## United States Patent and Trademark Office

APPLICATION NO.	FILING DATE	FIRST NAMED INVENTOR	ATTORNEY DOCKET NO.	CONFIRMATION NO
10/783,339	02/20/2004	Brian Smidt	10646.399US01	6914
7:	590 10/03/2006		EXAMINER	
Merchant & Gould P.C.			PAHNG, JASON Y	
P.O. Box 2903 Minneapolis, M	P.O. Box 2903 Minneapolis, MN 55402-0903		ART UNIT	PAPER NUMBER
		•	3725	
		DATE MAILED: 10/03/2006

_X <i>U</i>				
,	Application No.	Applicant(s)	0				
Advisory Action	10/783,339	SMIDT ET AL.					
Before the Filing of an Appeal Brief	Examiner	Art Unit					
	Jason Y. Pahng	3725					
The MAILING DATE of this communication appe	ars on the cover sheet with the c	orrespondence add	lress				
THE REPLY FILED <u>25 August 2006</u> FAILS TO PLACE THIS AI	PPLICATION IN CONDITION FOR	ALLOWANCE.					
.   The reply was filed after a final rejection, but prior to or on the same day as filing a Notice of Appeal. To avoid abandonment of this application, applicant must timely file one of the following replies: (1) an amendment, affidavit, or other evidence, which places the application in condition for allowance; (2) a Notice of Appeal (with appeal fee) in compliance with 37 CFR 41.31; or (3) a Request for Continued Ex

Figure A. Anvil including a Wedge-Shaped Portion and a Rectangular Portion

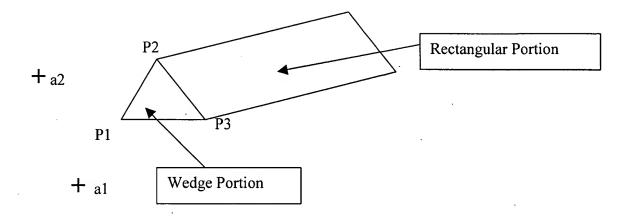
With regard to the Zehr reference, Applicant argues that Zehr does not disclose a rectangular portion and a wedge-shaped portion (page 6). However, Zehr discloses bars with triangular cross sectional shape. Therefore, Zehr discloses a rectangular portion and a wedge-shaped portion as shown below in attached Figure A.

With regard to the Zehr reference, Applicant also argues that Zehr does not disclose a second reference point being located farther from the axis of rotation than the first reference point (page 6). This is not true. See Figure A. If axis, a1, is chosen, then the second reference point further than the first reference point, P1, is either P2 or P3. If axis, a2, is chosen then the second reference point further than the first reference point, P1, is also either P2 or P3.
